FINAL ENVIRONMENTAL IMPACT STATEMENT

MILLIKEN CLEAN COAL TECHNOLOGY DEMONSTRATION PROJECT
New York State Electric & Gas Corporation
Milliken Generating Station
Lansing, New York

August 7, 1992

Wind Rose - Cayuga, New York 1975-1976.

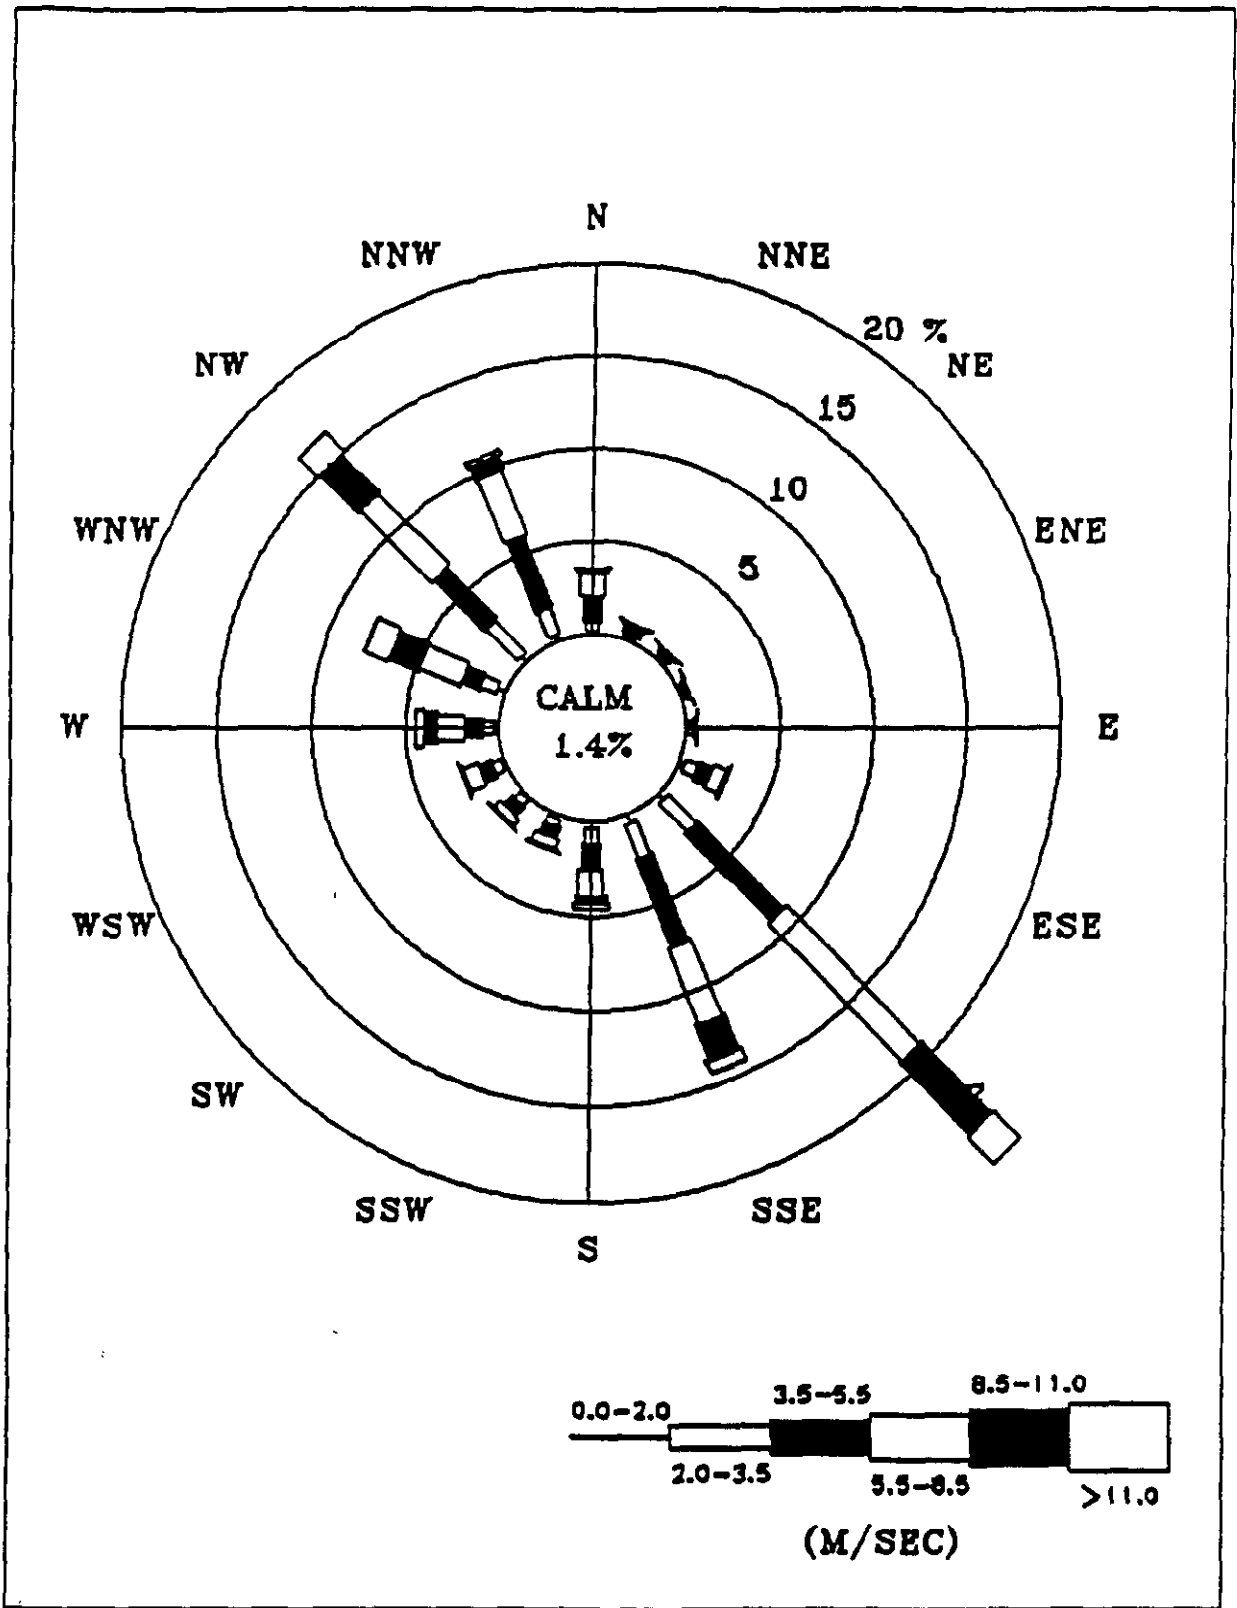
Comment 2: Mr. Frederick J. Holman asks that a wind rose showing prevailing wind direction be included with the FEIS.

Response: A wind rose summarizing annual wind patterns at Milliken is attached.

CORRECTED FIGURE 4.15-15

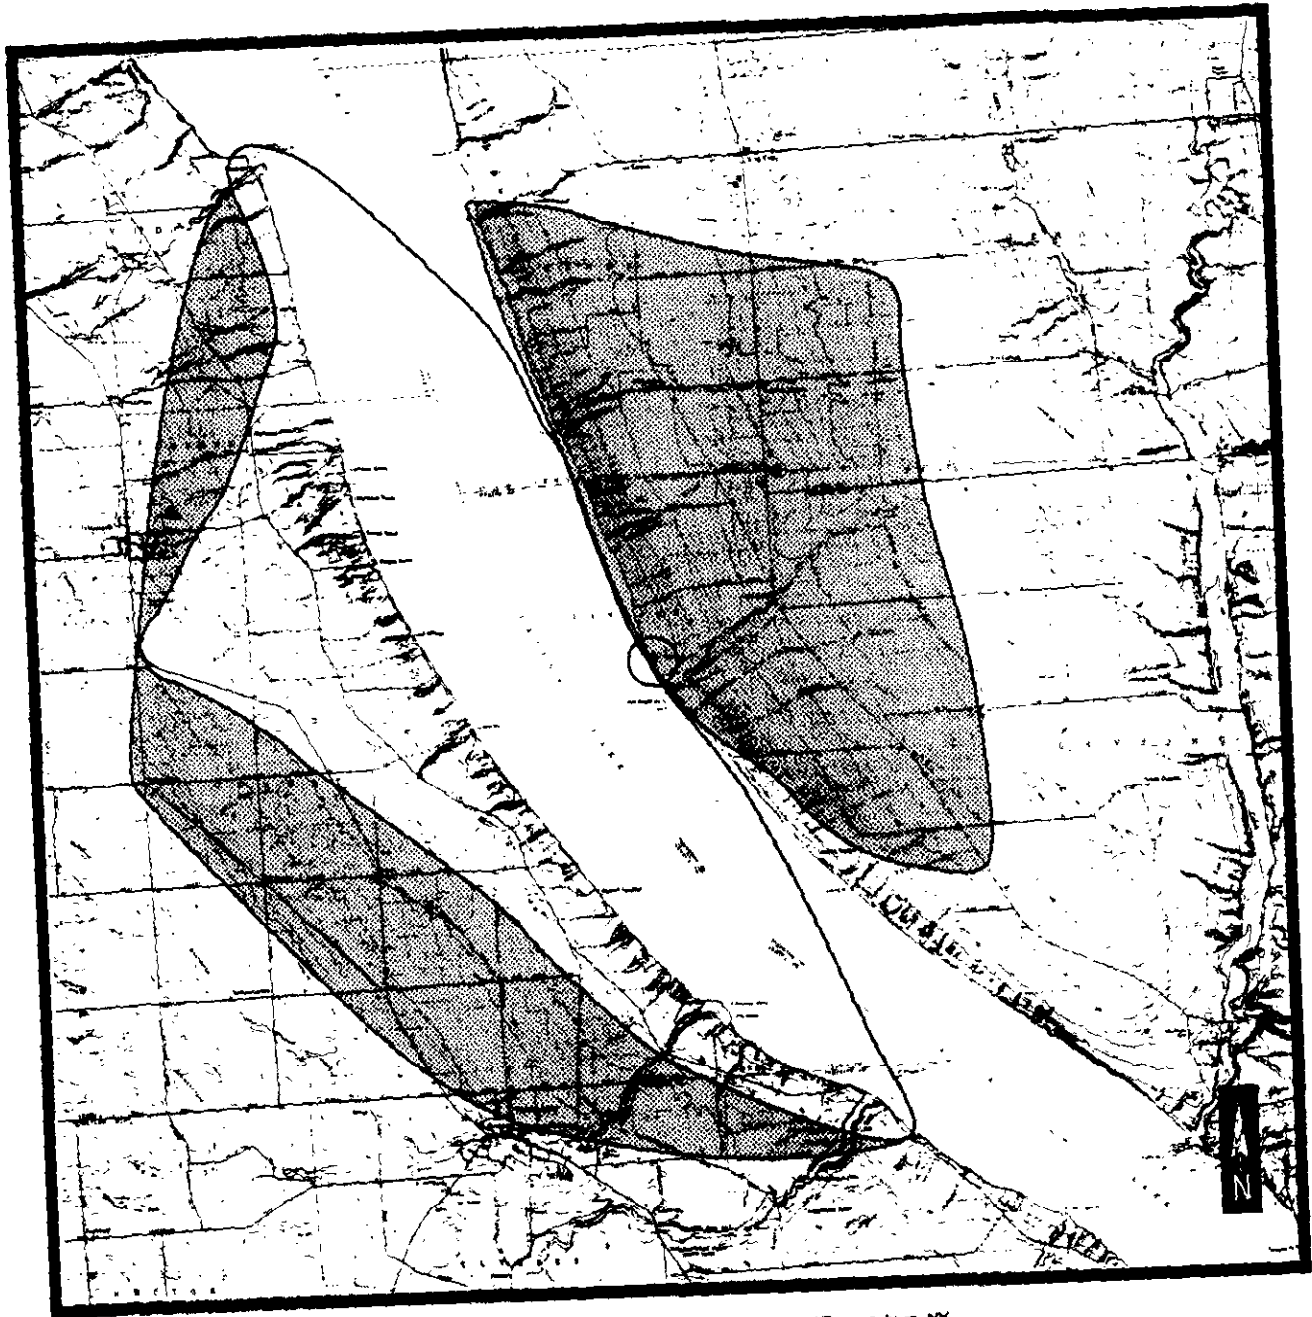
Comment 3: Mr. Frederick J. Holman points out that Figure 4.1.5-15 in the DEIS should be revised to illustrate views from line-of-sight origin locations #23, 24, and 25. He also points out that Figures 4.1.5.1 2A, 4.1.5.1 2B, 4.1.5.1 3A, and 4.1.5.1 3B were incorrectly labeled.

Response: Corrected figures are attached.
